## PLUG AND ABANDONMENT PROCEDURE

### Gallegos Canyon Unit #313

Re: Permanent Abandonment  
Well: Gallegos Canyon Unit 313

CONDITIONS OF APPROVAL

## Proposed P&A

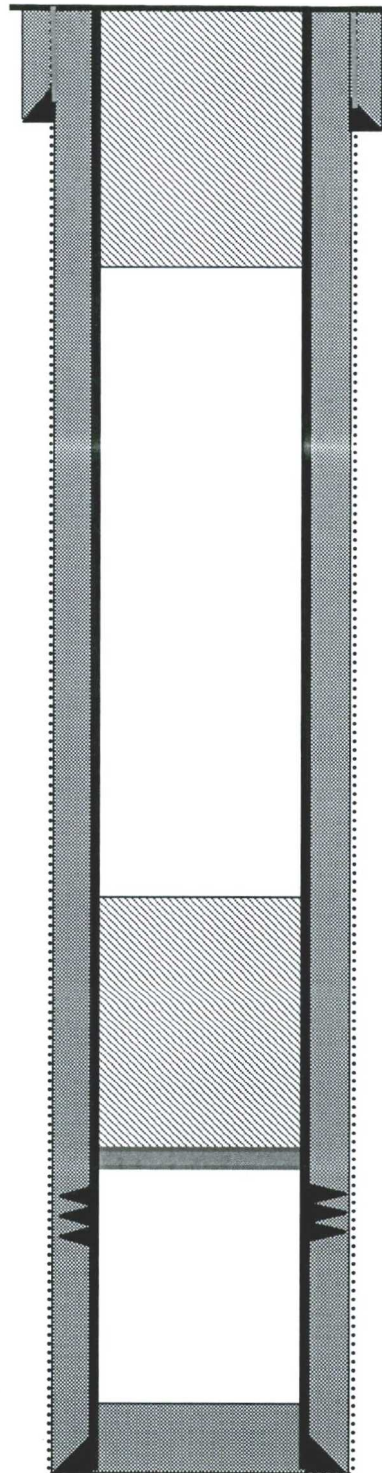
a) Set Plug #1 (1319 - 960) ft. to cover the Fruitland top. BLM picks top of Fruitland at 1010 ft.
